# ALLIANCE TO SAVE ENERGY

## **RE: Comment on the proposed revision of ENERGY STAR for windows, doors, and skylights. Recommendation that labels include a simple indicator of relative solar heat gain**

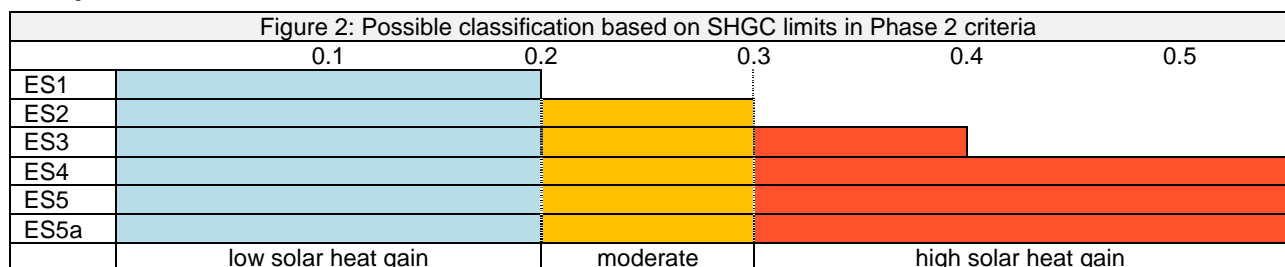
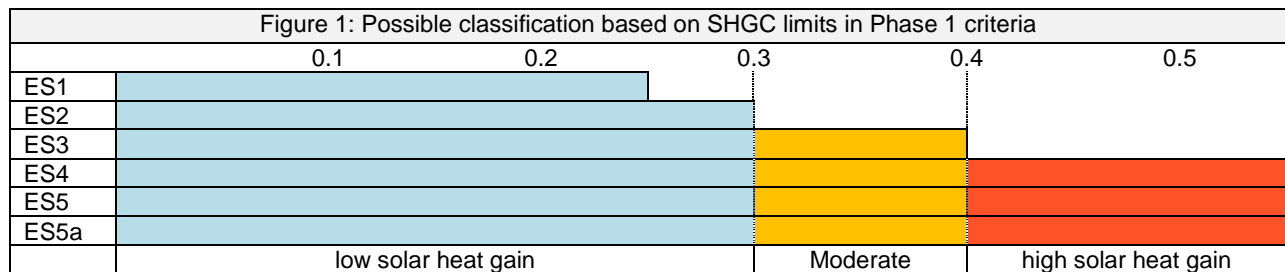
The proposed new criteria for ENERGY STAR windows offer a basis for defining 3 categories of high, moderate, and low solar heat gain:

- Windows with an SHGC that can only qualify in the northern climate zones ES4, ES5, and ES5a (SHGC >0.40) could be considered “high solar heat gain.”
- Windows meeting the criteria of cooling-dominated climates ES2 (SHGC ≤0.30) could be considered “low solar heat gain.”

- Windows with an SHGC of 0.31-0.40 that meets the mixed-climate criteria of ES3 but does not qualify further south could be considered “moderate solar heat gain” (see Figure 1).

- Under the new criteria as presently proposed, this classification could work for both Phase 1 and Phase 2. However, the average SHGC of products qualifying in Phase 2 can be expected to be substantially lower, not only because of a more stringent SHGC limit in ES1, but also because of the lower SHGC that comes with triple-pane windows. Therefore it seems reasonable to use lower SHGC numbers for the classification of relative solar heat gain in Phase 2 (see Figure 2). For dynamic windows with variable SHGC, “variable solar heat gain” would be the appropriate designation.
